Narrabri Gas Project: Review of baseline and ongoing groundwater data requirements under conditions of approval

Matthew Currell (Ph.D.)

8th July, 2021

This report outlines my expert opinion regarding the specifics of additional data and analysis required to meet the conditions of approval relevant to groundwater (B41 and B39) for the Narrabri Gas Project. It outlines both minimum and best practice requirements to address these conditions.

Figure 1 – Indicative locations where additional groundwater monitoring bores and baseline data are required to characterize aquifer health in Gunnedah-Oxley basin. Modified from Narrabri Gas Project EIS Water Baseline Report (2018).

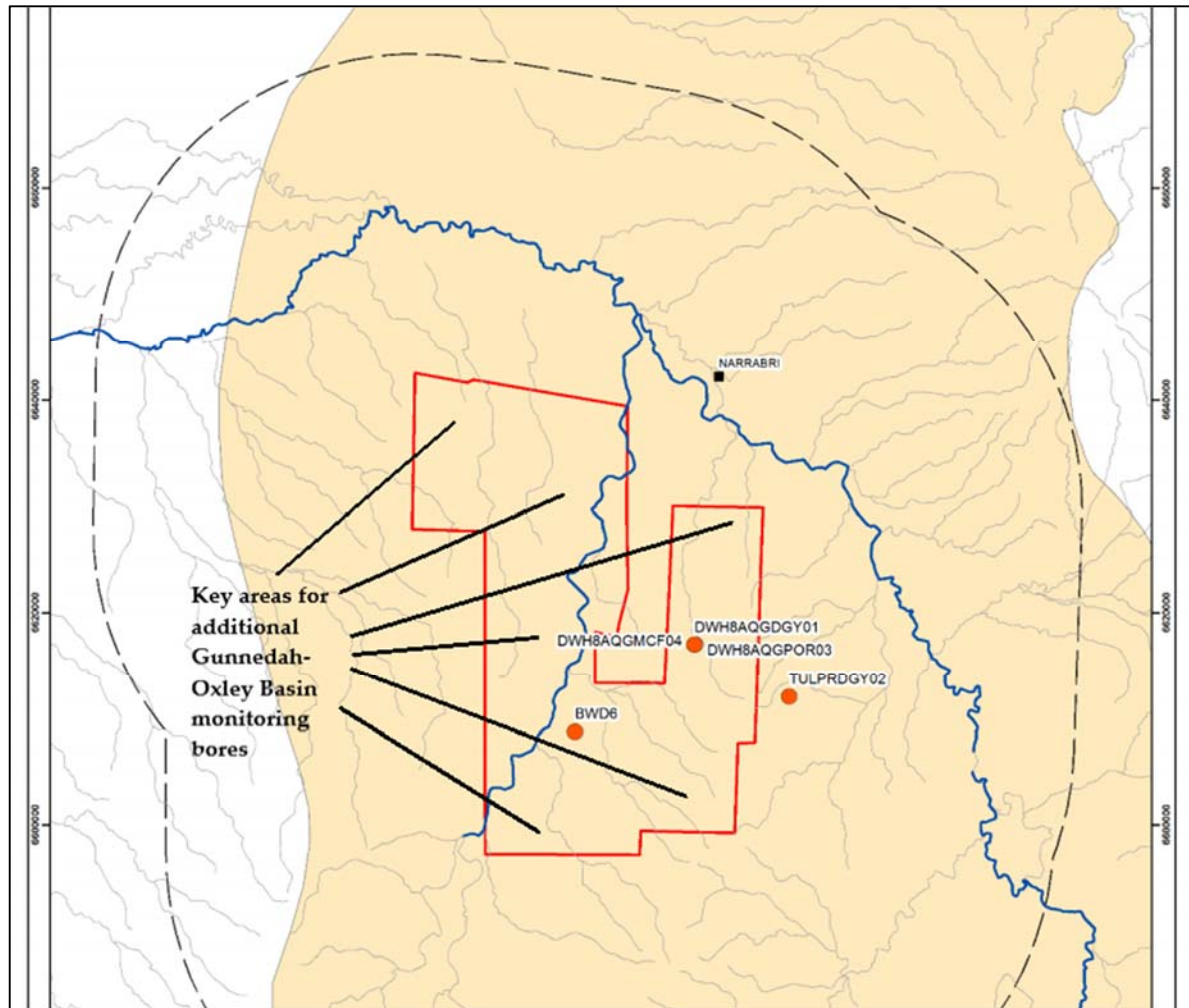
- ***Gunnedah Oxley Basin:*** Only two existing GOB monitoring bore sites for which baseline data have been reported in the Water Baseline Reports are within the project boundary (Figure 1). Additional bores thus need to be installed spanning the full project area, including sites both on the western and eastern half of the petroleum lease. Additional locations where monitoring bore data are urgently needed to address the current gaps are marked in Figure 1 below.

- While generally there is comparatively less existing groundwater extraction for irrigation supply within the GOB (i.e., compared to the GAB and Namoi Alluvium), the construction of additional groundwater monitoring bores in the GOB is critical. Many landholders have water bores drawing supplies from within the Gunnedah-Oxley Basin units for domestic, potable and stock usage, and are highly dependent on these. These bores are likely to be particularly vulnerable to impacts from CSG, due to their depth and relatively close proximity to the gas-bearing formation(s) and baseline data are also critical to protection of these bores.

- Further, the data obtained from GOB monitoring bores will be the primary method to understand water level impacts of gas development deep in the aquifer system (i.e., within or close to the depth of water and gas extraction for CSG) and provide early information about the extent of drawdown impacts modification. This was highlighted in the IESC in their advice on the project in 2017:

Comprehensive baseline groundwater level data from bores in the GOB is also necessary to understand potential vertical leakage impacts in the aquifer system (as specified in the subsequent parts of condition B41) and inform improved groundwater modelling, in line with condition B39 (see below).

Based on the gap analysis above, an additional 7 to 8 GAB monitoring bores and at least 6 GOB monitoring bores would be required to complete the minimum coverage needed for characterization of groundwater levels, flow patterns and aquifer health in these units, as per condition B41. Best practice/maximum requirements would include additional sites beyond this number to map out flow patterns and gradients in further detail.

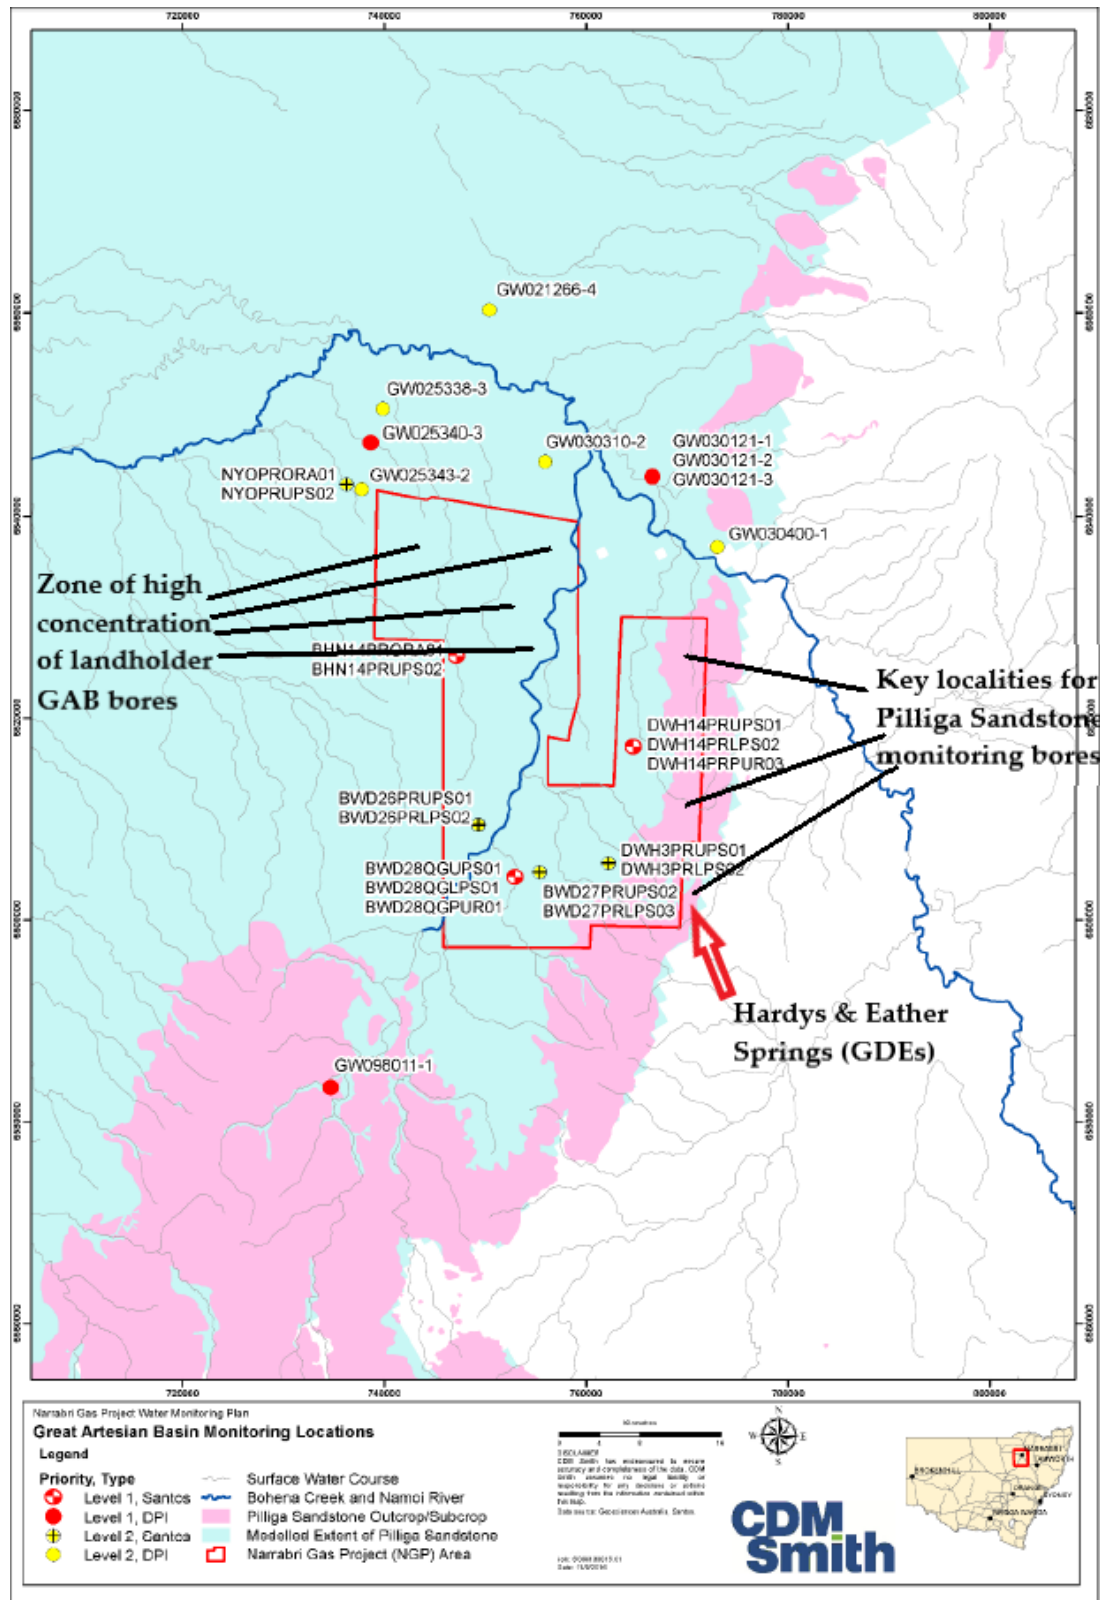
- **Great Artesian Basin:** In the current baseline groundwater datasets, while there are a greater number of monitoring bores in the GAB compared to other units, the monitoring bores are limited or missing in key areas within the project boundary. In particular, monitoring bores and baseline data are needed where the Pilliga Sandstone - the key GAB water supply unit in the area, outcrops along the east of the project area (marked in pink on Figure 2 below). It is critical that this zone, where groundwater recharge potential into the GAB is highest, is equipped with monitoring bores, to collect level (and quality) data, and properly understand groundwater recharge rates, mechanism(s) and quality. This is fundamental to characterization of aquifer health (in accordance with B41), water balance and flow patterns. Bores in this region are also vital for the characterization of GDEs, their source aquifer(s) and interactions with the aquifer system, including the springs identified as having high ecological significance by the IESC (2017) – i.e., Hardys and Eather Springs (see section 8 on GDEs below).

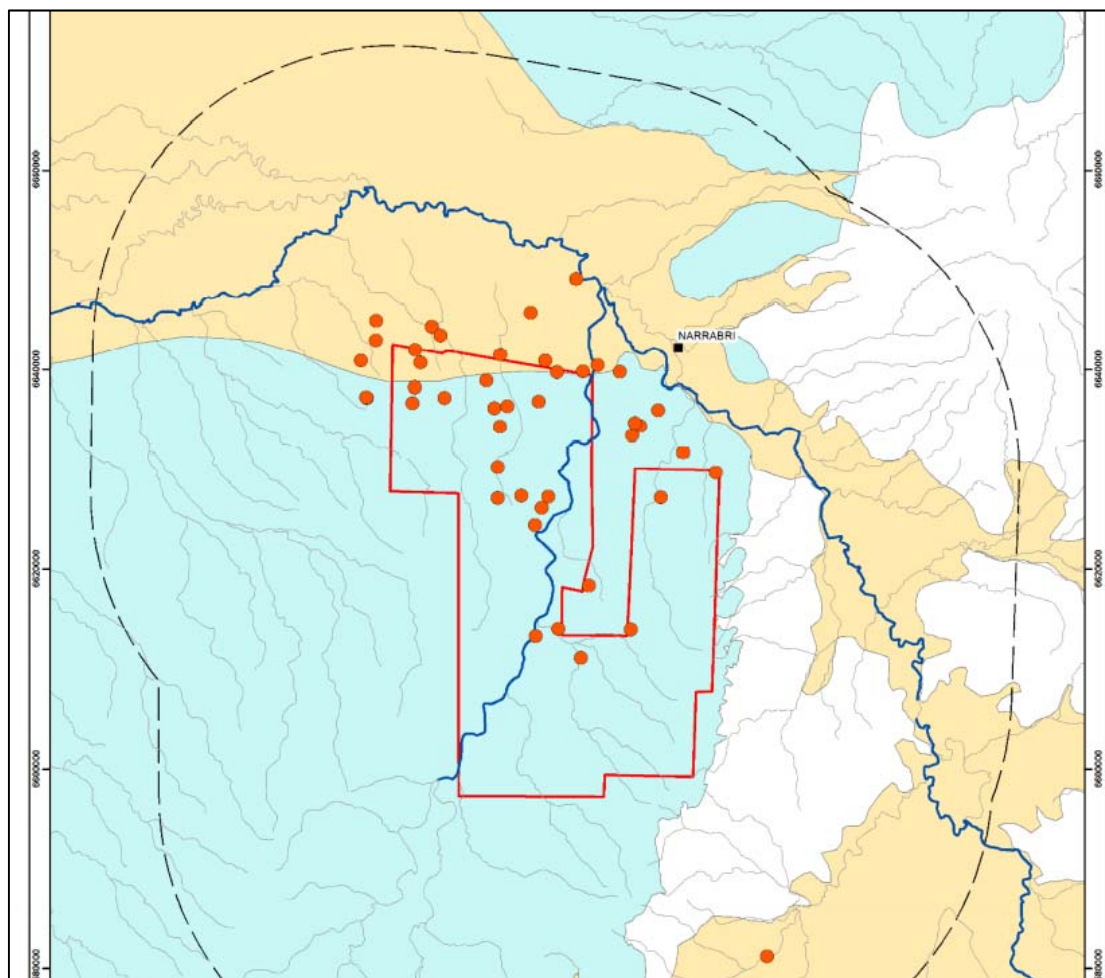
- In addition to the eastern GAB outcrop/recharge areas, there is also a large area of the northwestern part of the project area with no GAB monitoring bore coverage, where a significant number of landholder bores within the GAB occur (see Figure 3 below). Multiple bores should be installed in

this region to properly characterize groundwater levels and aquifer health in this key area of GAB water supply:
